MONITORING YEAR 3 ANNUAL REPORT

GLADE CREEK II RESTORATION PROJECT

RE: Monitoring Year 3 (MY3) Report – Draft Submittal
Glade Creek II Mitigation Project
DMS Project # 92343
Contract Number 6843
New River Basin - #CU# 05050001 - Alleghany County, North Carolina

Wildlands Engineering, Inc. (Wildlands) has reviewed the Division of Mitigation Services (DMS) comments from the Draft Monitoring Year 3 report for the Glade Creek II Mitigation Project. The following Wildlands responses to DMS's report comments are noted in italics lettering.

UT Glade Creek (STA 11+29 - STA 14+48)

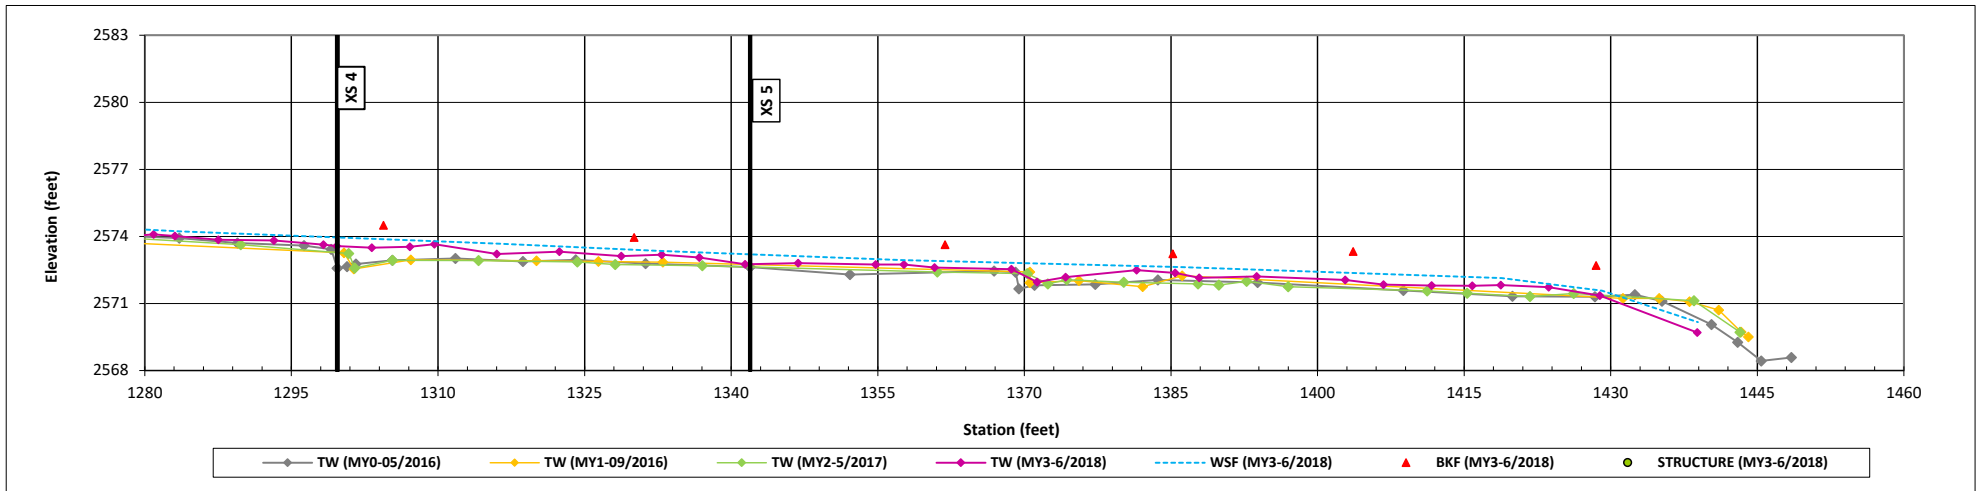
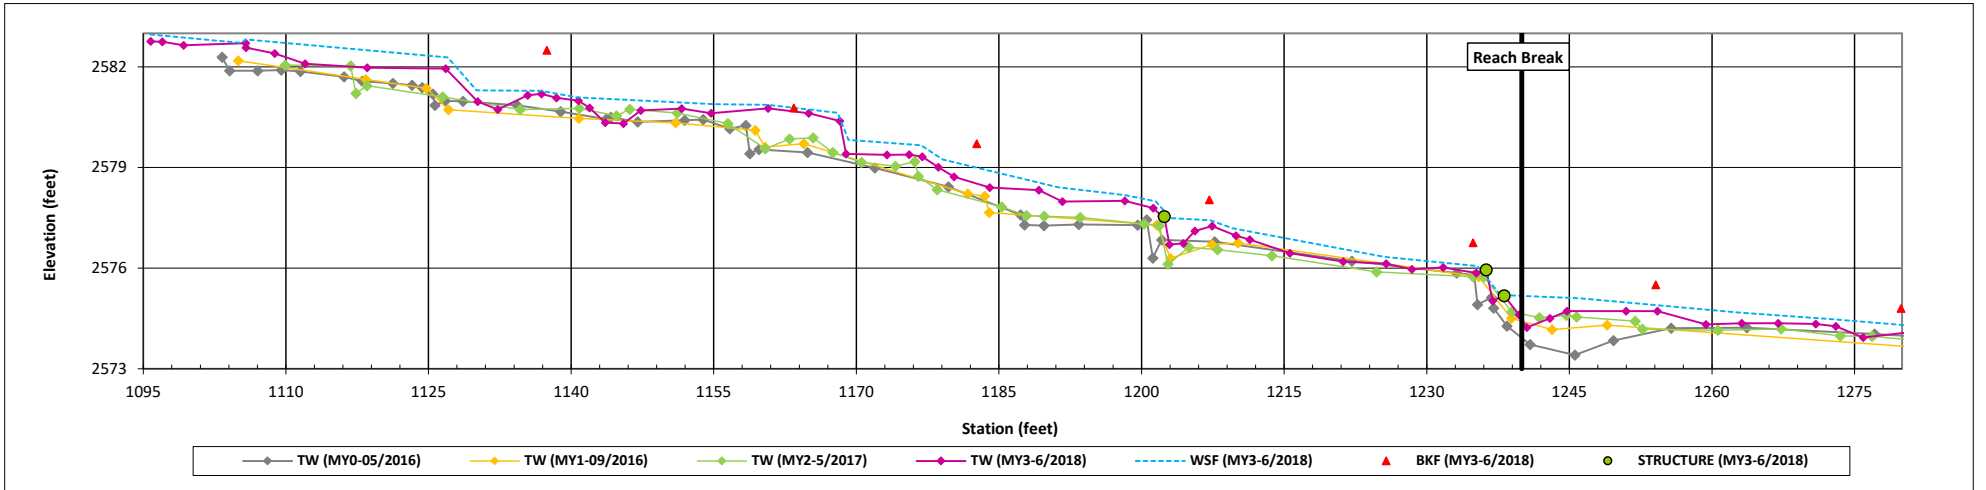
DMS comment; Section 1.2.4, Stream Areas of Concern – DMS concurs that sediment has redeposited along this reach due to upstream cattle impacts combined with storm events. This was clearly evident following Hurricane Florence. Can Wildlands estimate of the linear feet of impacted channel where wetland features predominate over stream features?

Wildlands response; Wildlands estimates that there are approximately 50 linear feet (STA 12+60 to 13+10) of impacted channel on UT to Glade Creek where wetland features predominate over stream features based on the visual assessment that occurred on 11/8/2018.
